MISSISSAUGA BUS RAPID TRANSIT

ENVIRONMENTAL ASSESSMENT ADDENDUM

March 2010

McCormick Rankin Corporation
in association with
Ecoplans, Ltd.

MCCORMICK RANKIN CORPORATION	 MISSISSAUGA Transportation and Works	DATE: August 2008	MISSISSAUGA BRT PROJECT ENVIRONMENTAL ASSESSMENT ADDENDUM	FIGURE
					5-4
		 Transit	SCALE: 1:2,000	WINSTON CHURCHILL BOULEVARD ALTERNATIVE PROFILES

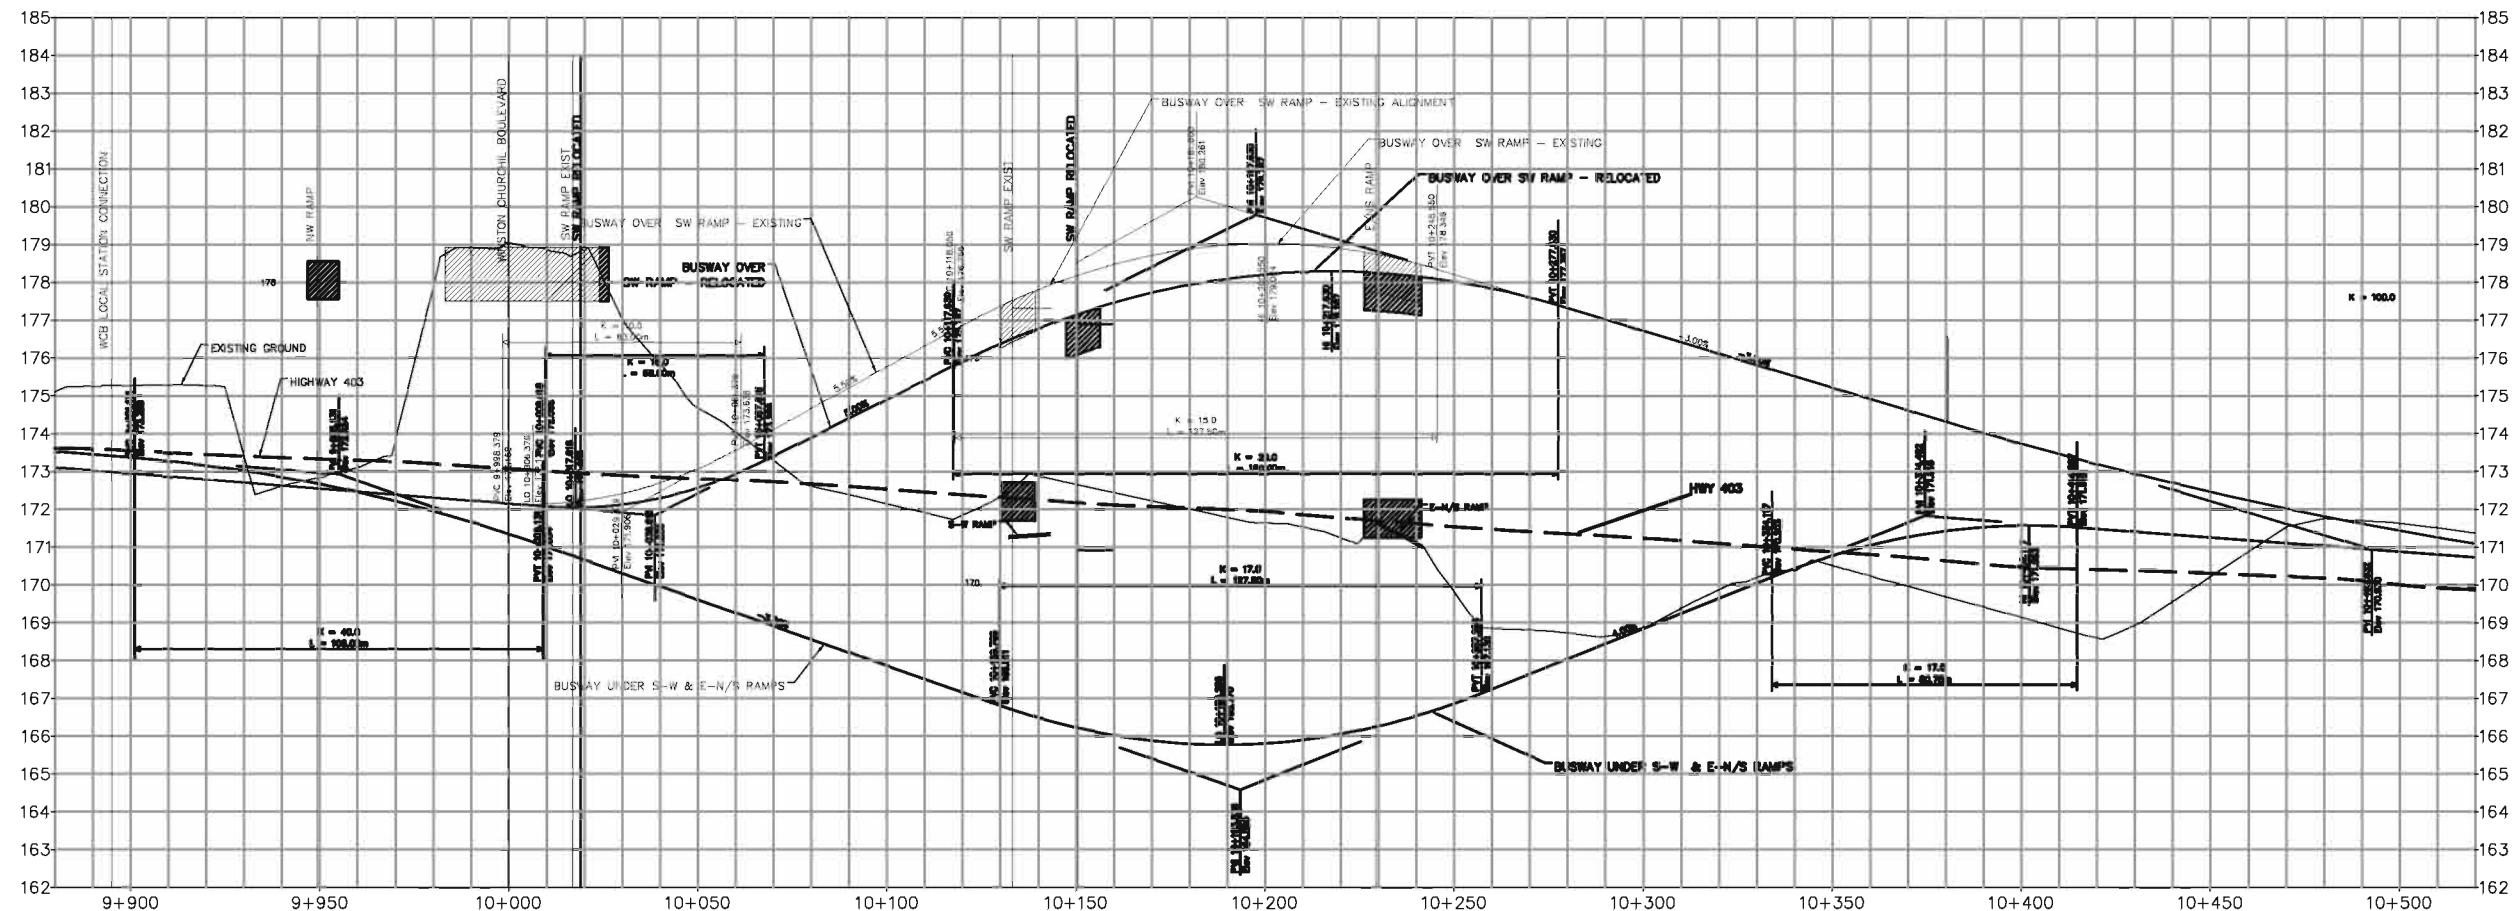
The alternative of crossing over the ramps is significantly less costly than going under. The impacts of these options on the community are both minor and mitigatable. Of the two “over” options, the one involving a realigned S-W loop ramp is less costly and incrementally better in most respects. The recommended alternative is shown on Figure 5-3.

MRC	McCORMICK RANKIN CORPORATION	MISSISSAUGA Transportation and Works	DATE	MISSISSAUGA BRT PROJECT ENVIRONMENTAL ASSESSMENT ADDENDUM	FIGURE 6-2
			SCALE	1:4,000	
			HURONTARIO STREET / RATHBURN ROAD RECOMMENDED ALTERNATIVE ALIGNMENT

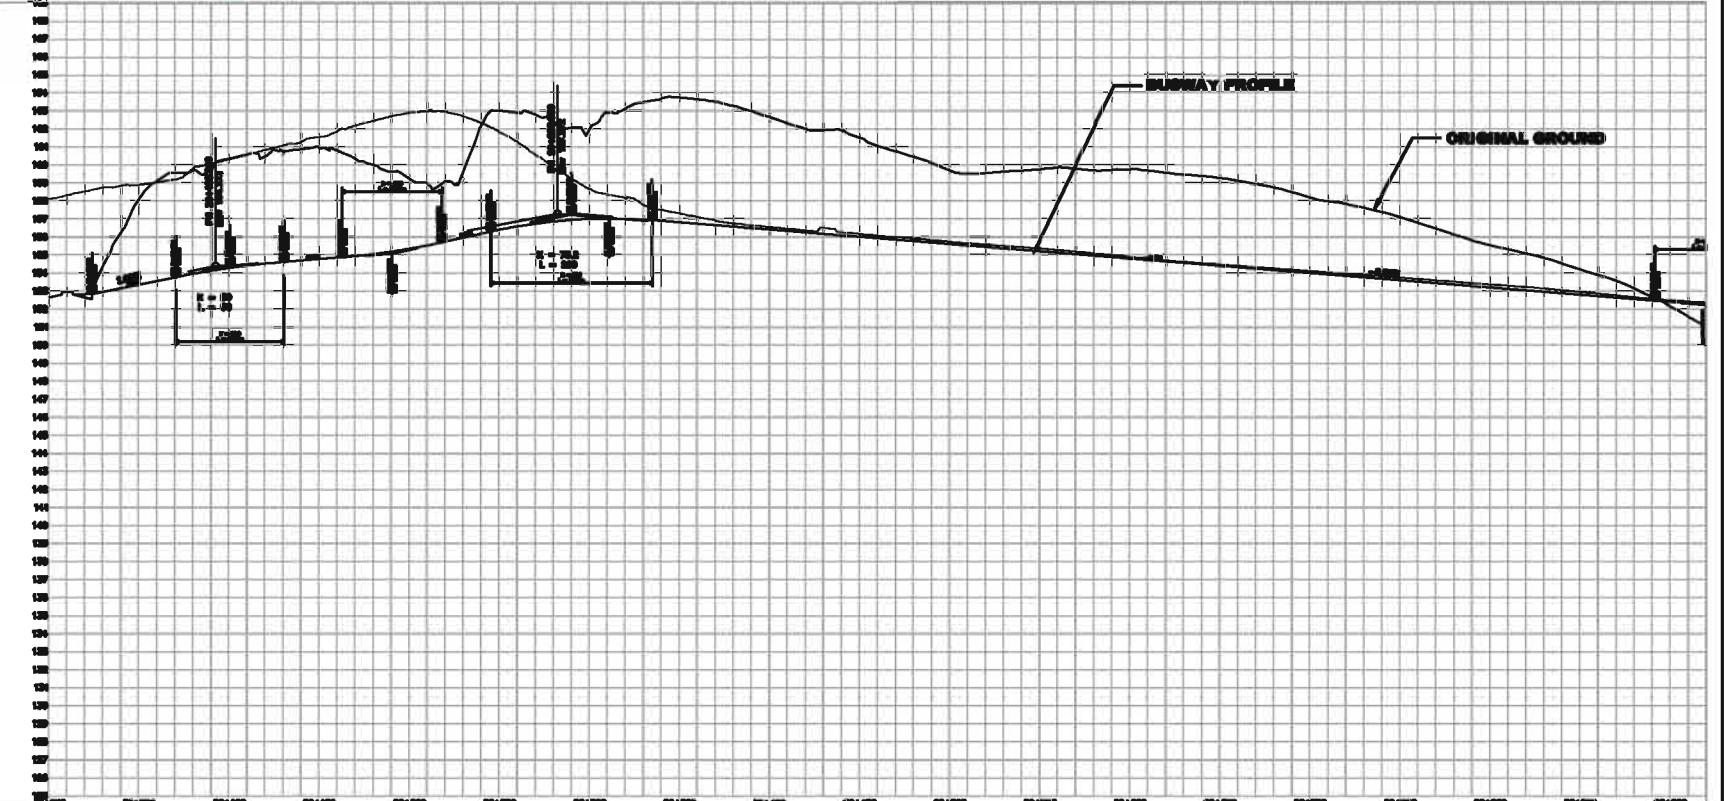
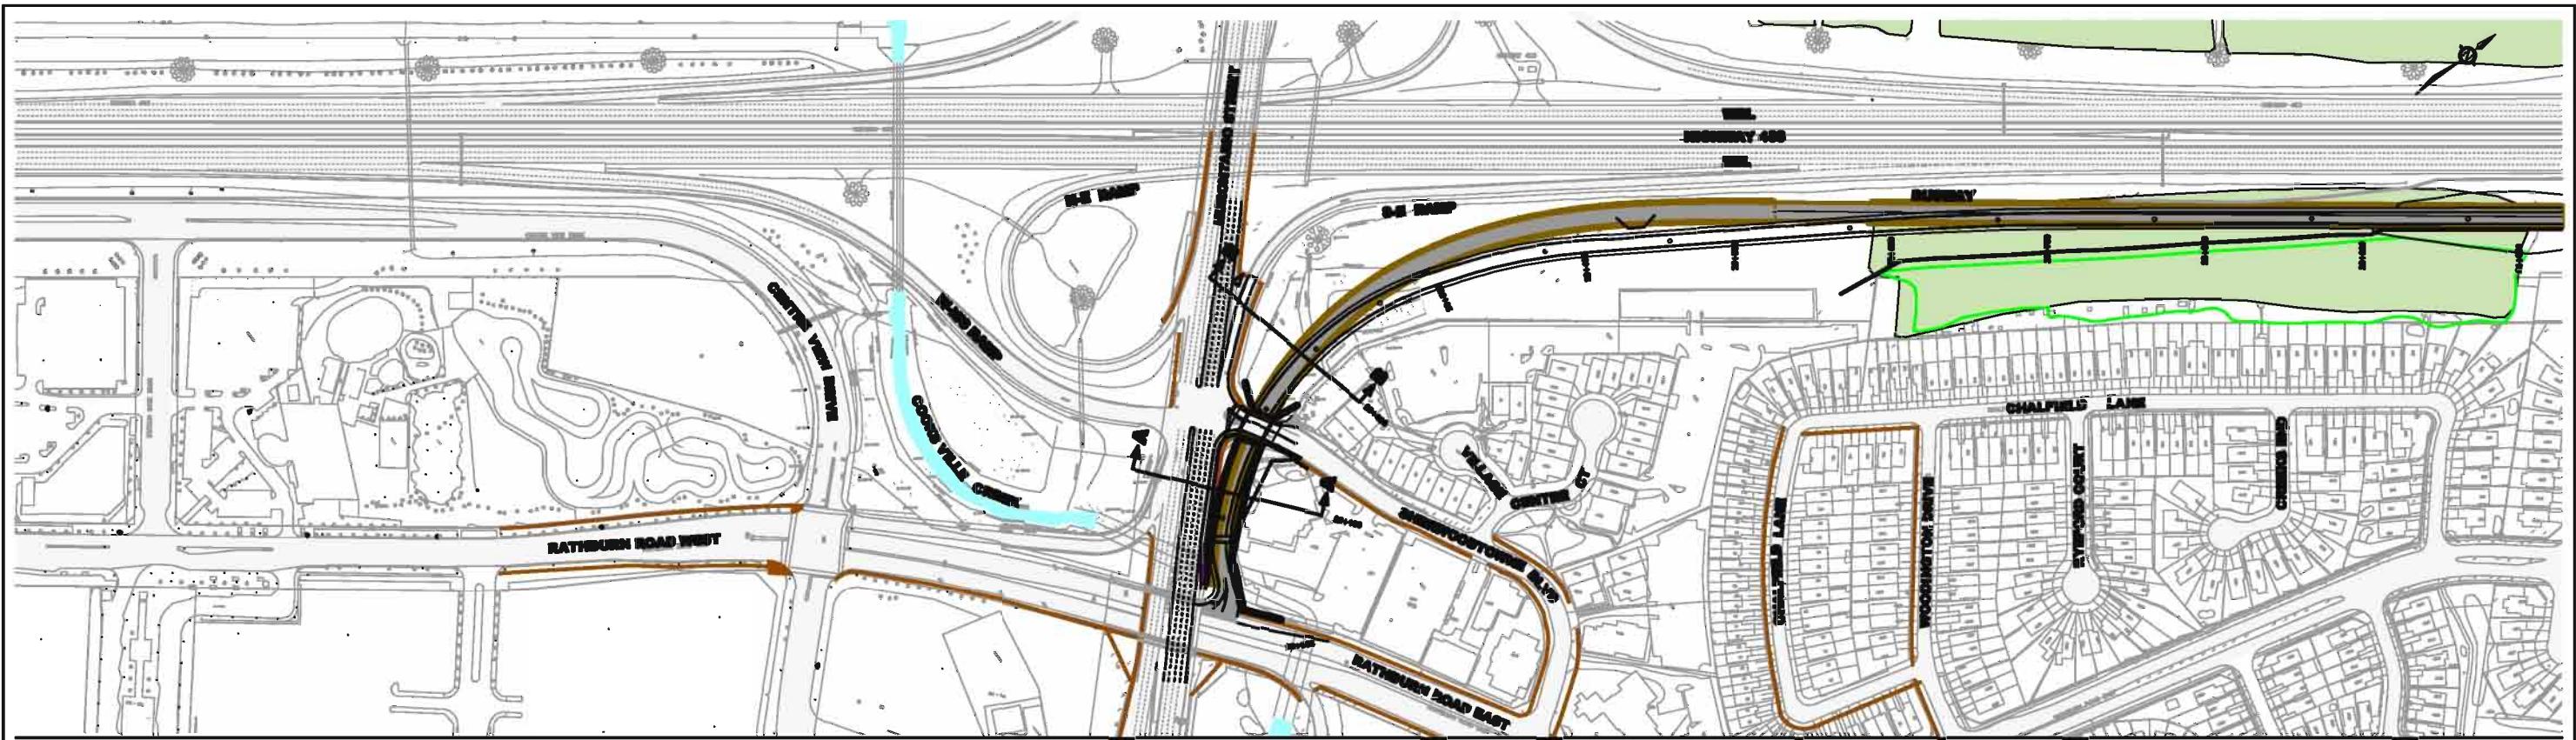
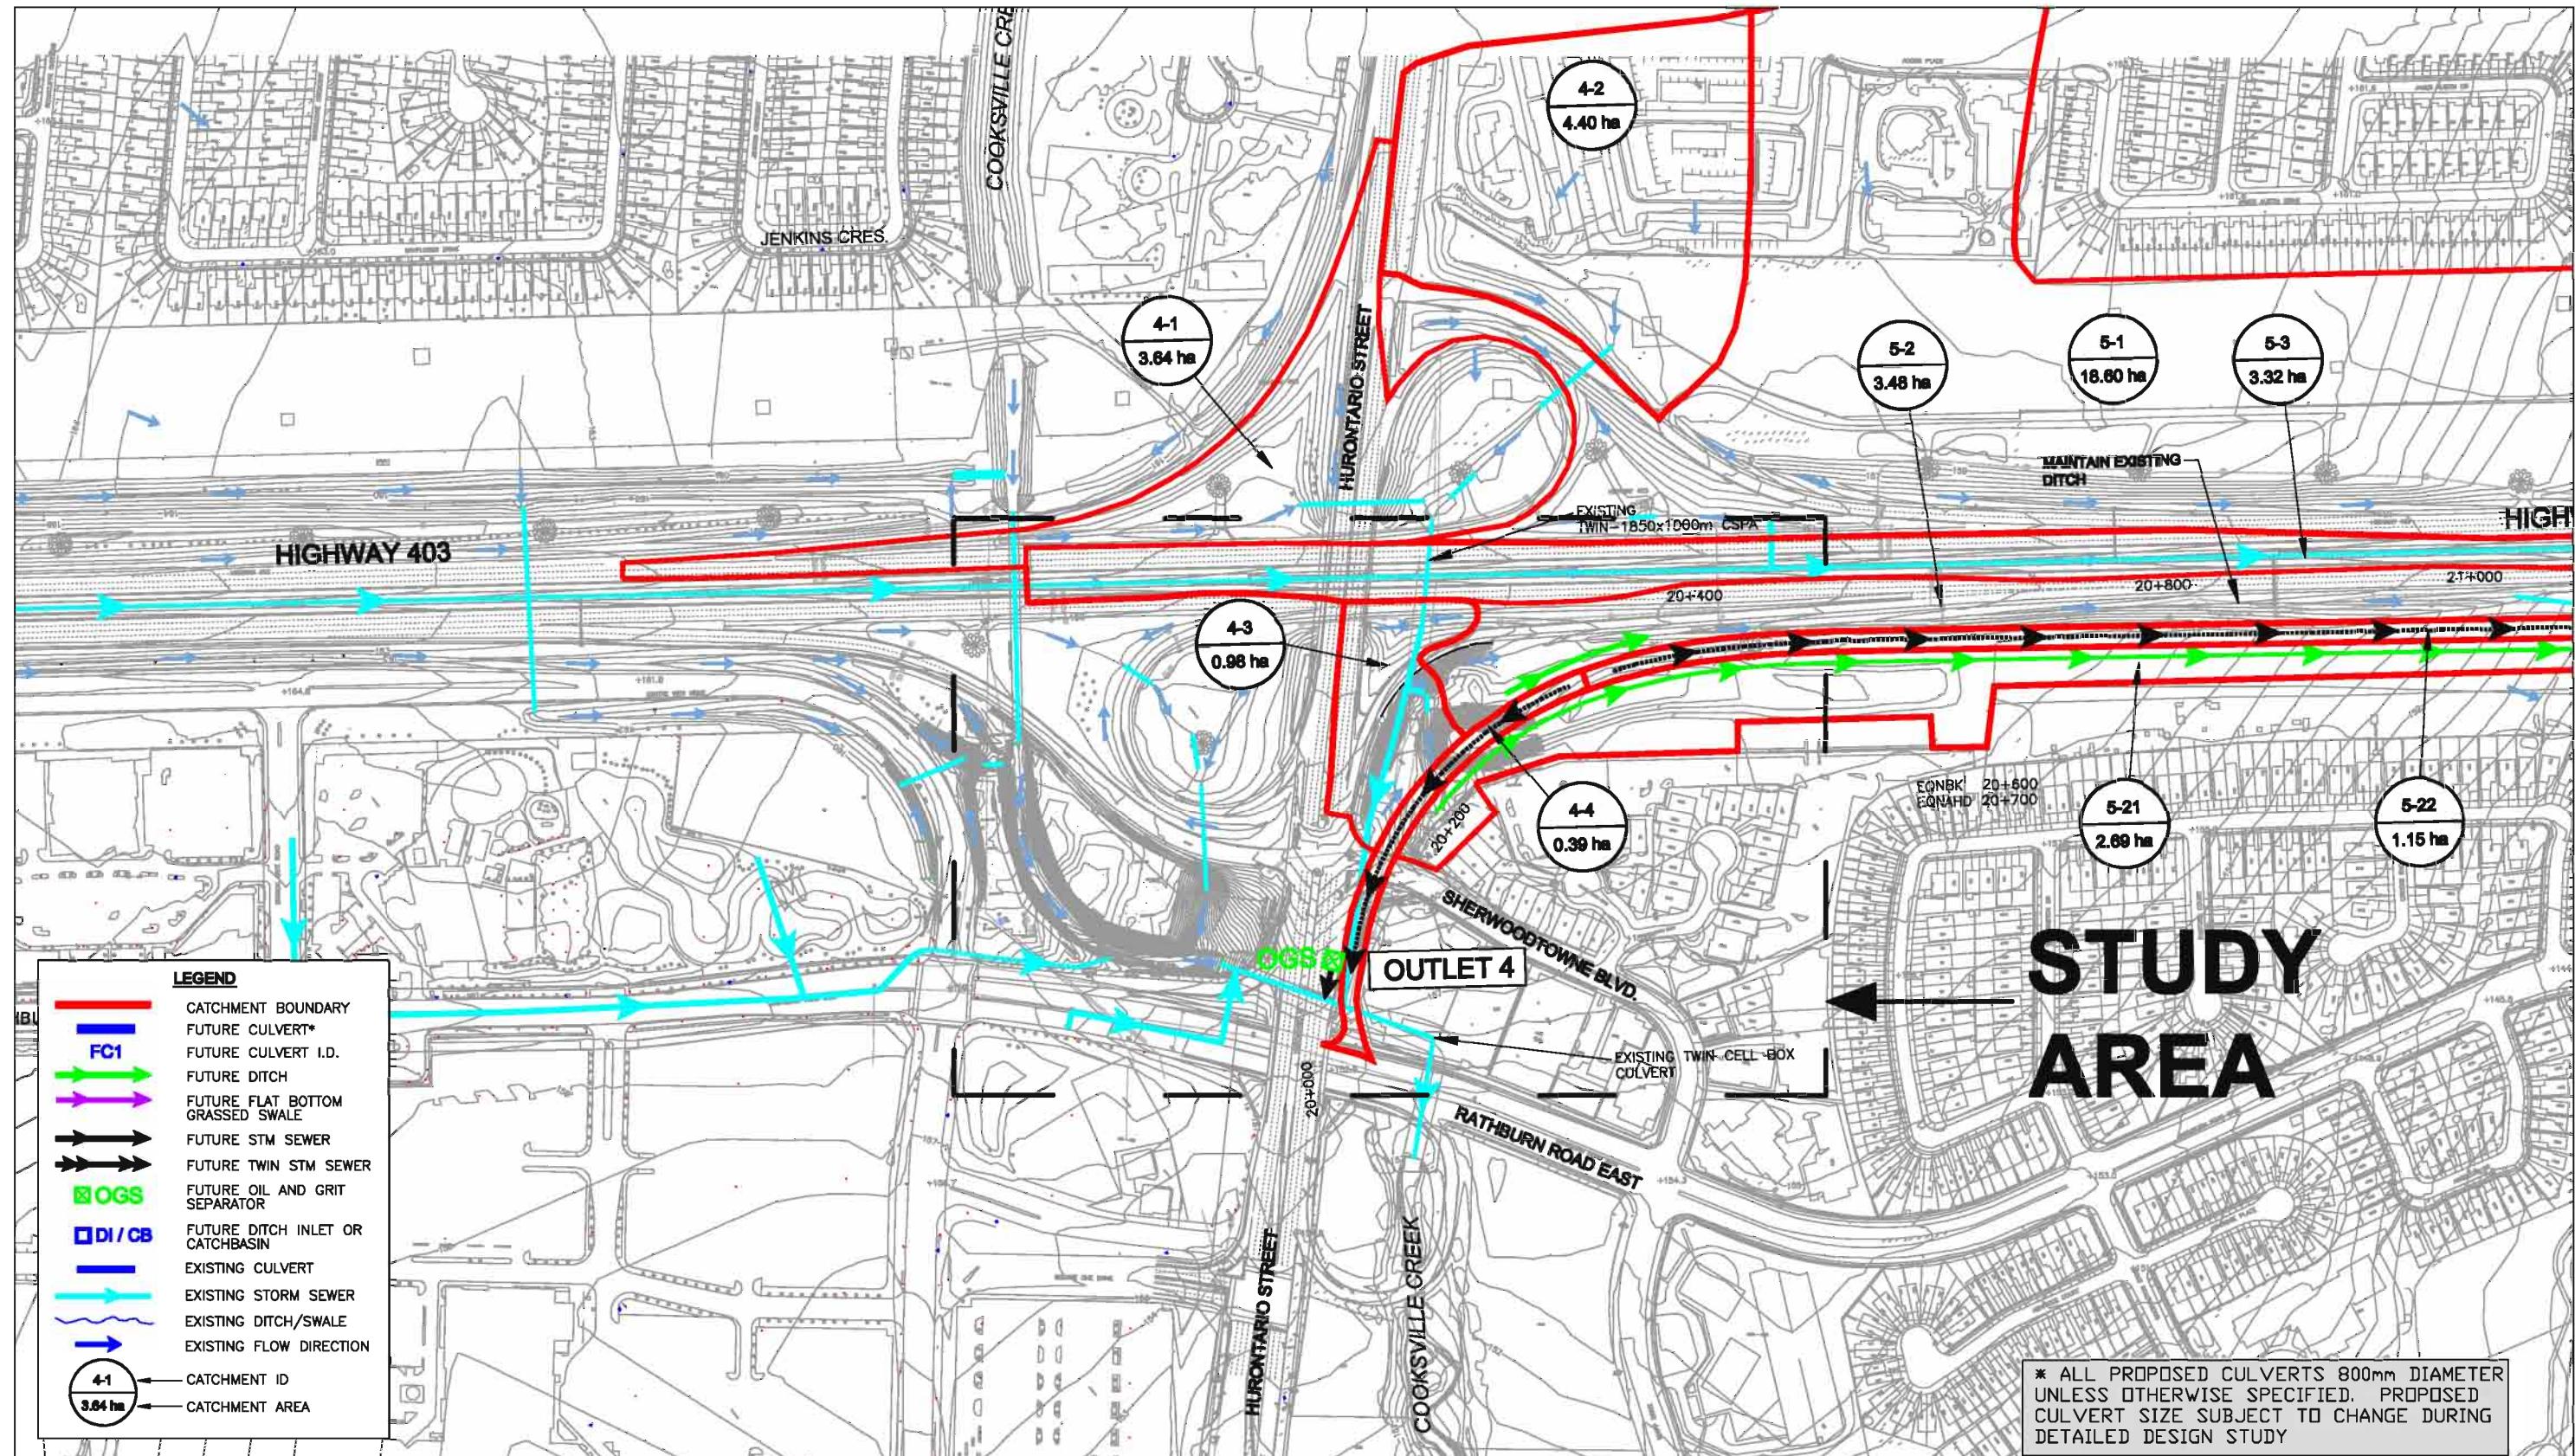
Analysis Factor	Base Case: Busway Under Hurontario Street to Centre View Drive (Figure 6-1)	Alternative: Busway Connection to Rathburn Road (Figure 6-2)
Natural Environment Impact	Requires future lowering of Cooksville Creek to accommodate ultimate busway extension through City Centre, and new major overflow culvert under Rathburn Road and Hurontario Street.	No impacts to Cooksville Creek or significant environmental features.
Cost (focus on major items that differ between alternatives)	Base Case: Structures: \$7.9 M Retaining Walls: \$6.3 M Cooksville Creek crossing: \$0.8 M (plus future overflow pipe est. \$2 M) Construction / staging: \$0.3 M	Saves approximately \$7 million over baseline alternative: Structures: \$2.2 M Retaining Walls: \$6.8 M Cooksville Creek crossing: \$1.3 M (permanent solution) Construction / staging: \$minimal

Sherwoodtowne Boulevard and along the east side of Hurontario Street to a new intersection with Rathburn Road. The proposed alternative is shown on Figure 6-2.
